D/DRC Case

1221-1301 Huger Street & 401-433 Gervais Street

DESIGN/DEVELOPMENT REVIEW COMMISSION
DESIGN REVIEW DISTRICT
EVALUATION SHEET
Informational Presentation

DESIGN/DEVELOPMENT REVIEW COMMISSION
CONCEPTUAL SITE/SUBDIVISION PLAN
REVIEWING AGENCY COMMENTS

BOOK	SF NO.
02B-1	226 23
PROJECT NO. 1814	SHEET NO. G1
DATE 6/03/2015

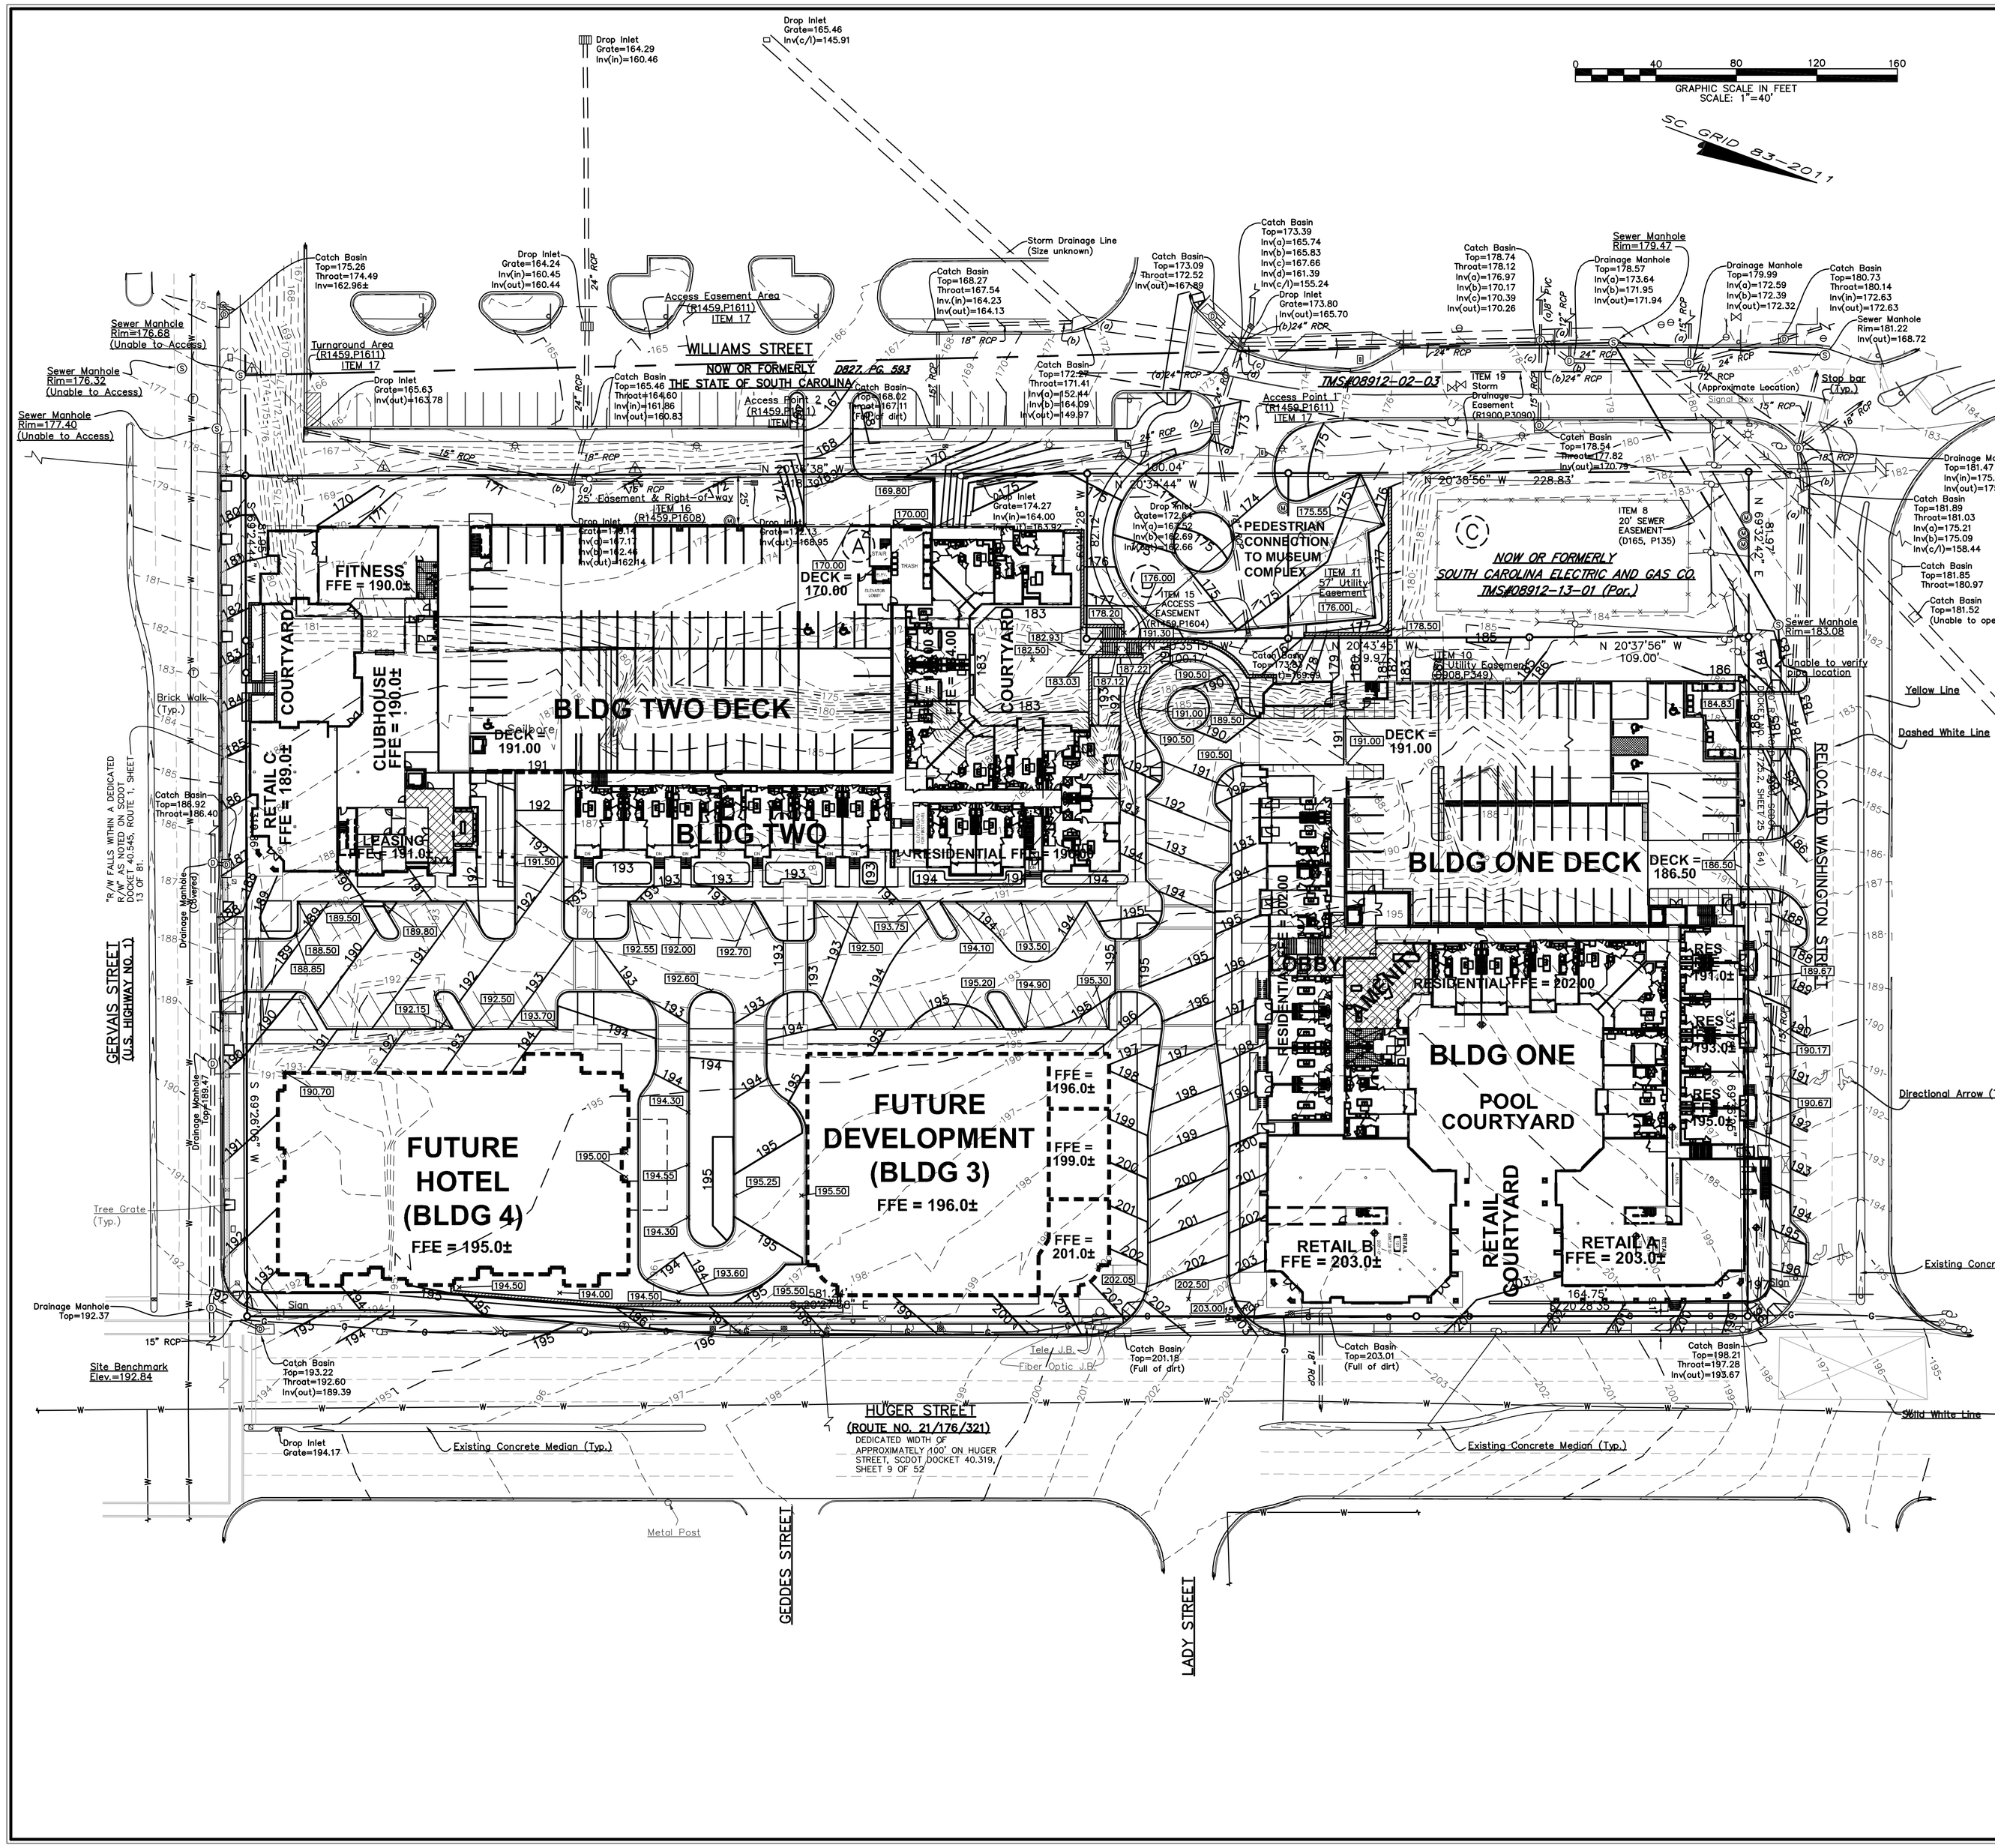
No.	DATE	DESCRIPTION
1	6/29/2015	REVISE GRADING IN AREA OF PEDESTRIAN CONNECTION TO MUSEUM

DDRC SITE PLAN

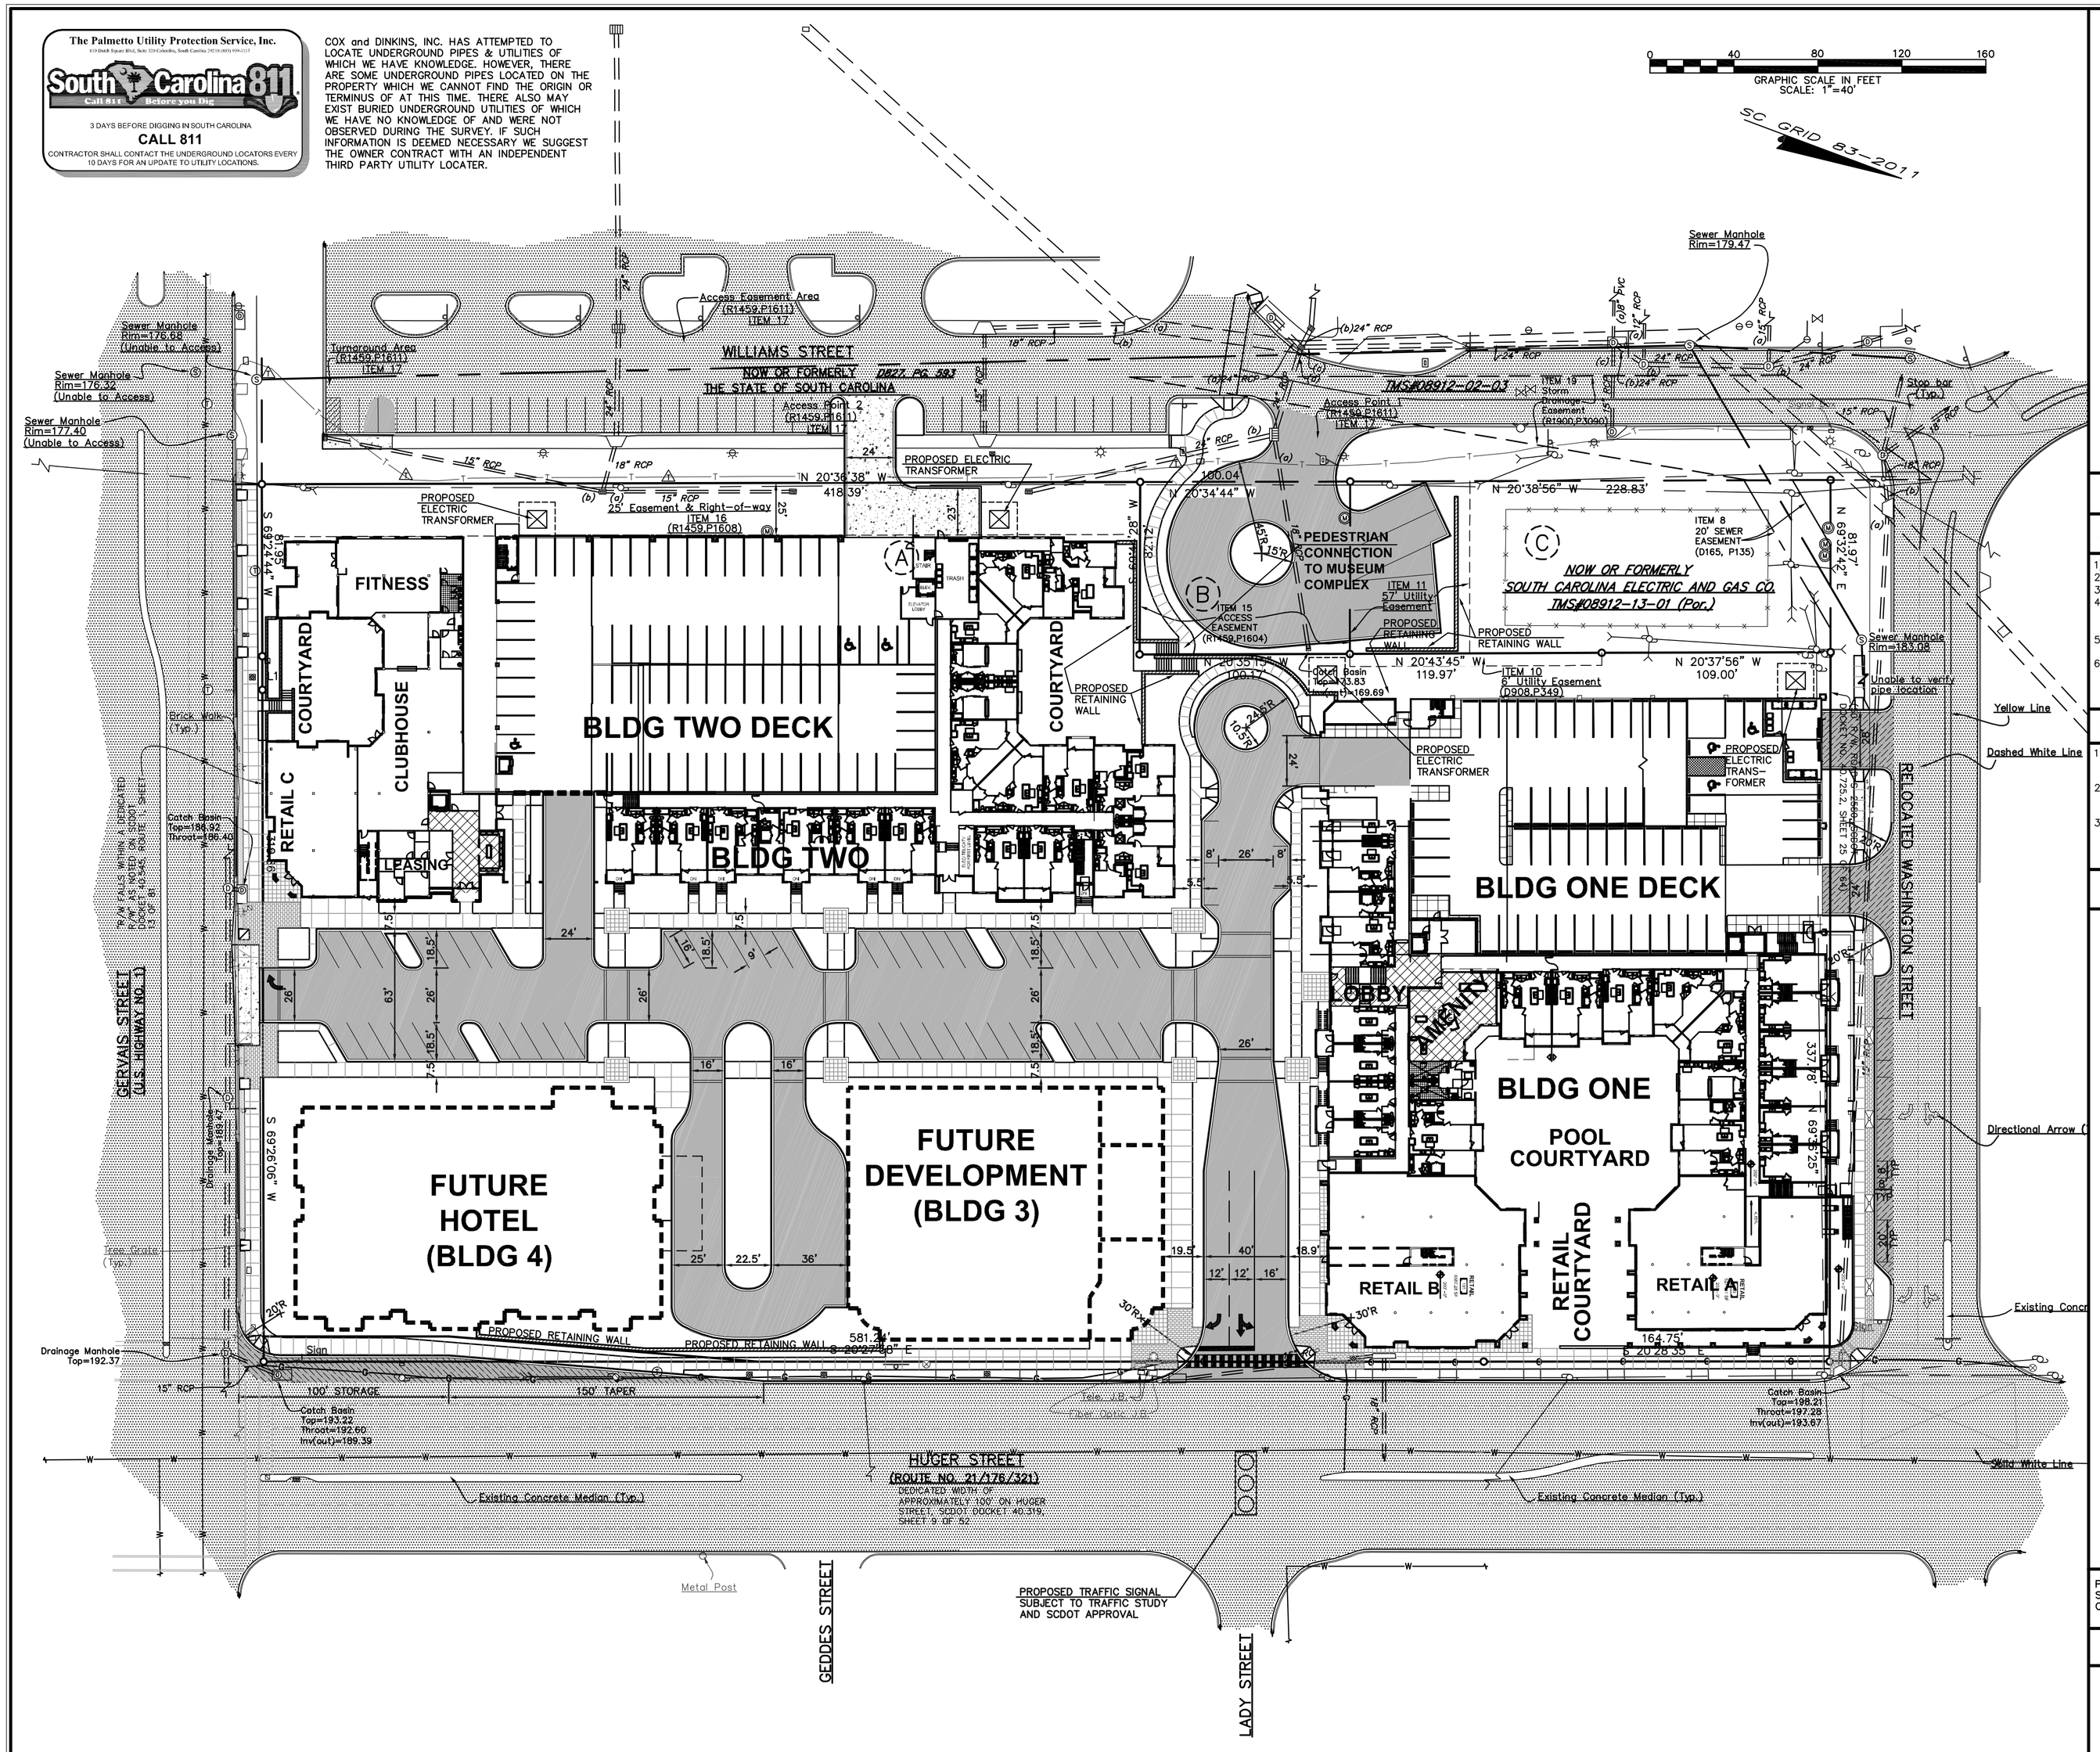
The setbacks are all within the recommended range. Building Two on Gervais has various setbacks from one foot to ten feet. The public sidewalk is about 12 feet wide to the curb, so the retail space to the east of the courtyard is closer to the street than the residential units on the west, which benefit from a larger setback and a planted buffer.

Building One on Huger is set back about six feet. This pus the face of the building about 14 feet from the curb, with a section that includes a three foot planting strip between the building and the sidewalk, a six foot sidewalk, and a five foot planting strip for trees between the sidewalk and the curb. This tree planting strip is essential in creating a buffer between the sidewalk and Huger Street. Having a wider sidewalk and a wider buffer would improve this section for pedestrian comfort.

Building One is set back from Washington about one foot, with the stoops encroaching into the right-of-way. The plan indicates a ten foot sidewalk, and a 10-12 foot semi-private sidewalk that accesses the units, separated by a knee wall. This puts the building face about 22' from the face of curb, which creates a nice separation for residential privacy that is appropriately urban in form.

Lady Street is on private property so does not have setback lines. Building One's retail space is 18' from the curb, allowing for a generous sidewalk and a five foot tree zone. The residential portion of Building One varies from 25' at the main lobby to 13'. As mentioned earlier, staff's concerns are primarily with the height of the residential units above the sidewalk at this western end of the building. Perhaps this wide planting area can be used to create more of an urban condition such as on some of the other residential units (stoops, knee-wall, etc.).

No.	DATE	DESCRIPTION
1	6/29/2015	ADD FOUR ISLANDS IN PARKING LOT; ADD PEDESTRIAN STAIR CONNECTION TO MUSEUM & ADJUST PARKING; REVISE COURTYARD FRONTING GERVAIS

EAST ELEVATION - OVERALL 1

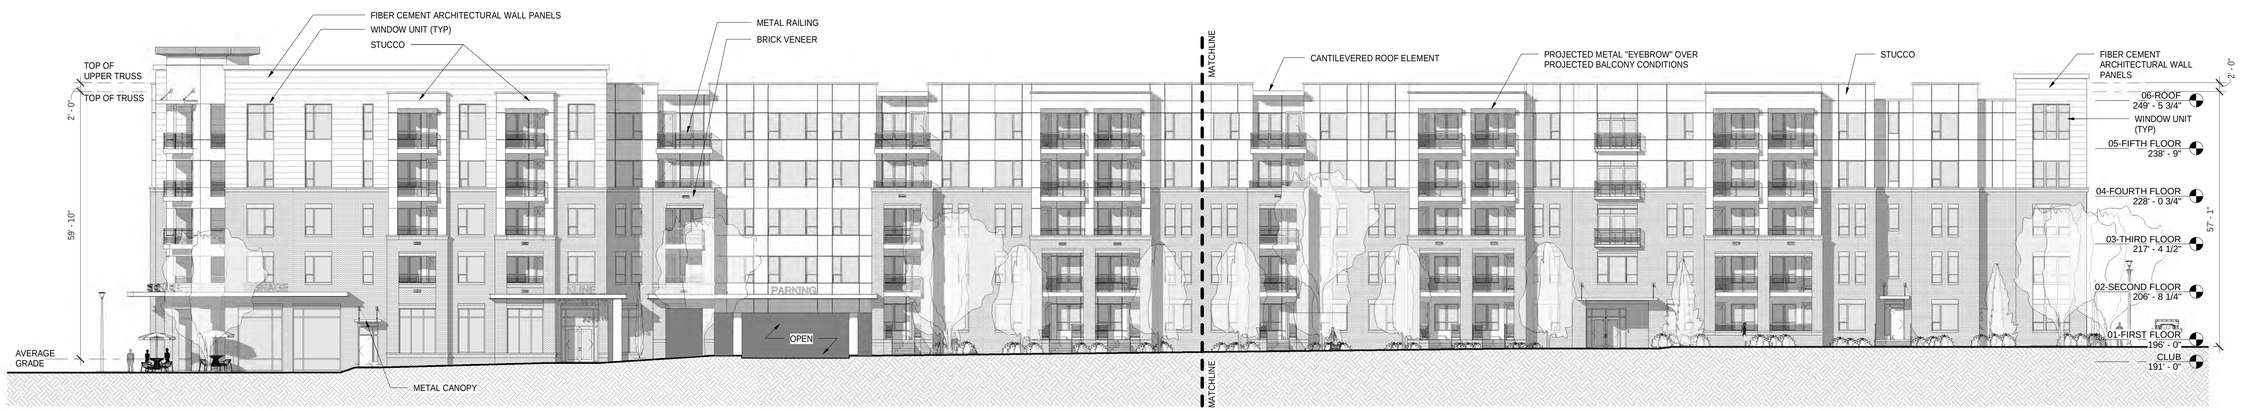
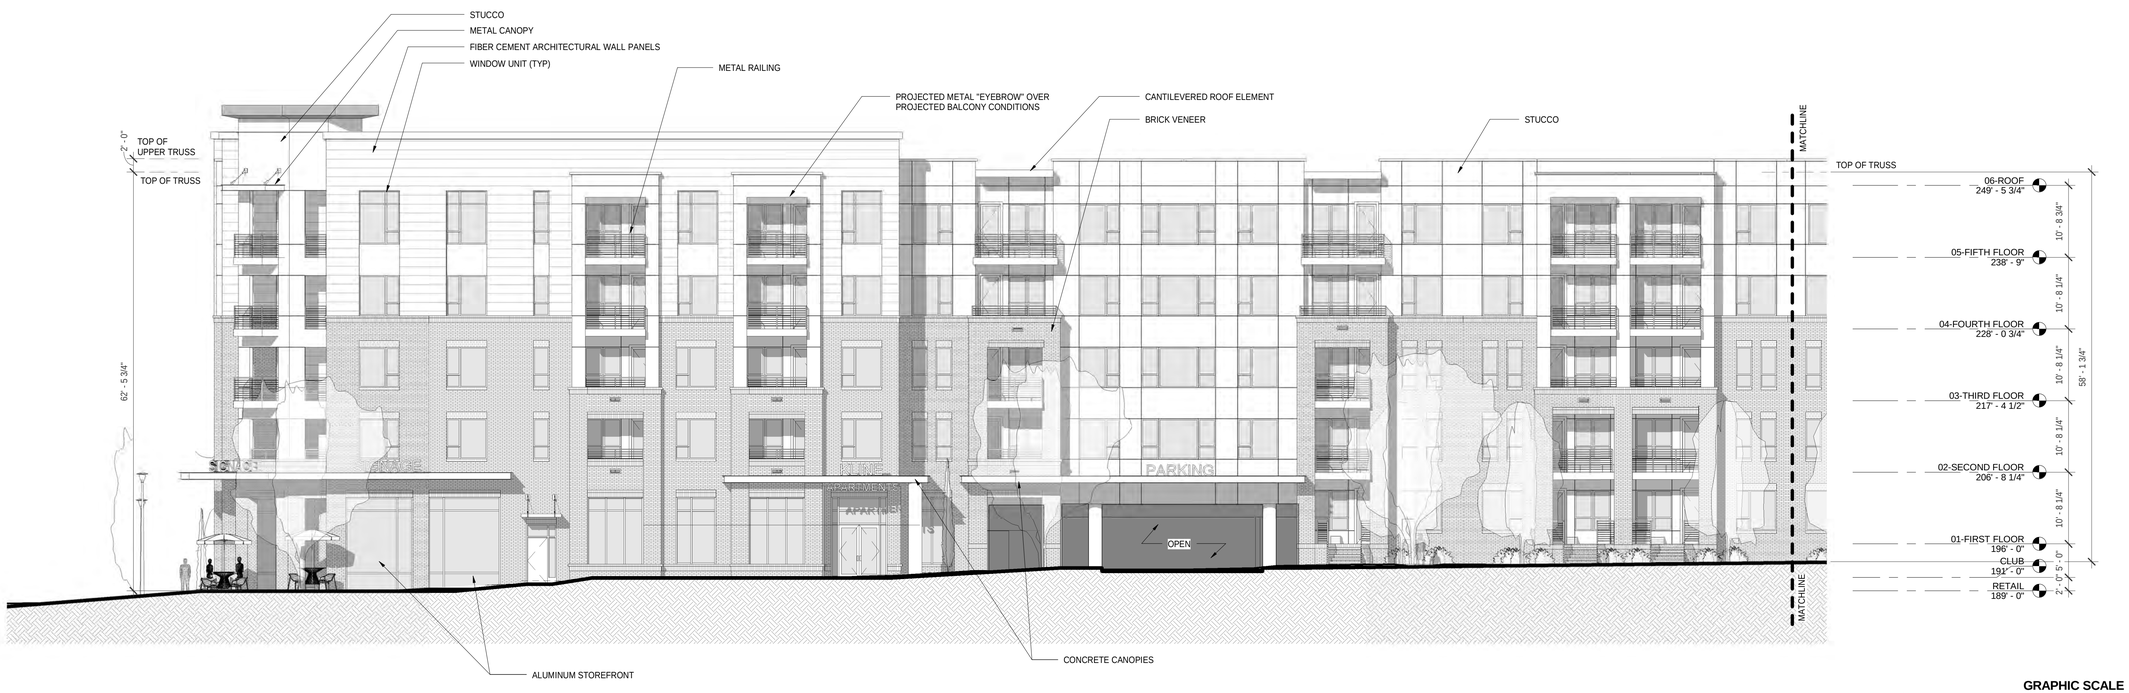
Building One has a good amount of storefront. The southern end of the Huger Street façade could use some more detailing at the street level. The north section of this Huger Street elevation is more successful with the loggia, railing, and brick detailing on the piers, etc. which provide additional detailing and interest. As the restaurant balcony turns the corner onto Washington Street, however, the blank wall below the patio starts at about five feet above the sidewalk and increases to eight along Washington Street. A slight adjustment has been made since earlier discussions with staff (it was formerly 7-11 feet above the sidewalk). However this is still not an acceptable condition along this façade.
